EB-2017-0049

Ontario Energy Board

AND IN THE MATTER OF the Application by Hydro One
Networks Inc.'s for 2018-2022 Distribution Rates.

Interrogatories of Energy Probe Research Foundation

Figure 1:
Distribution Productivity Savings

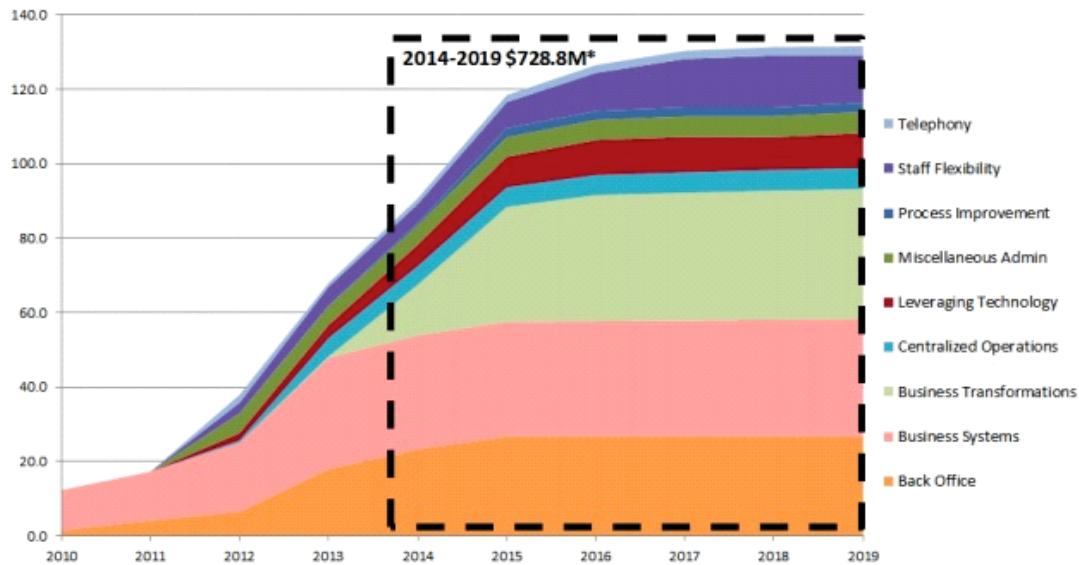
Preamble: In Hydro One's previous distribution rate application – EB-2013-0416, 2015-2019 rates – the utility estimated that it would achieve more than \$100 million annually in productivity savings between 2015 and 2019. When the test year, 2014, was included, those savings amounted to more than \$728 million in savings.

- a) Can Hydro One provide an update on the forecasted savings from its previous rate application?
- b) Are those productivity savings included in this application?
- c) Are the savings detailed in Hydro One's current application in addition to those laid out in the previous rate application?

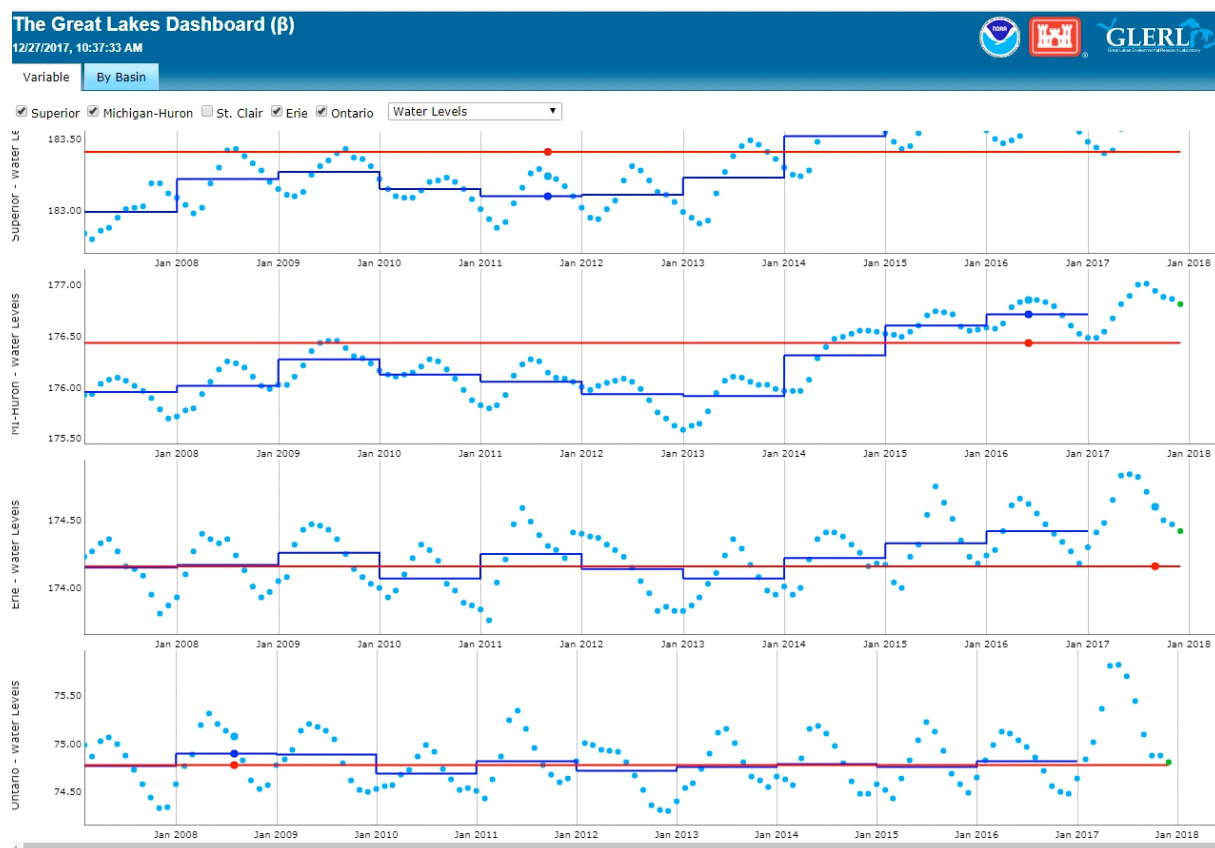
Preamble: Hydro One states that it is increasing its submarine cable maintenance programs to “meet challenges as a result of receding water levels in the Great Lakes...”

Data from the NOAA Great Lakes Environmental Research Laboratory suggest that water levels have increased in recent years.

Can Hydro One provide evidence that water levels in the Great Lakes are continuing to recede and what the direct cost of receding water levels is to the utility?
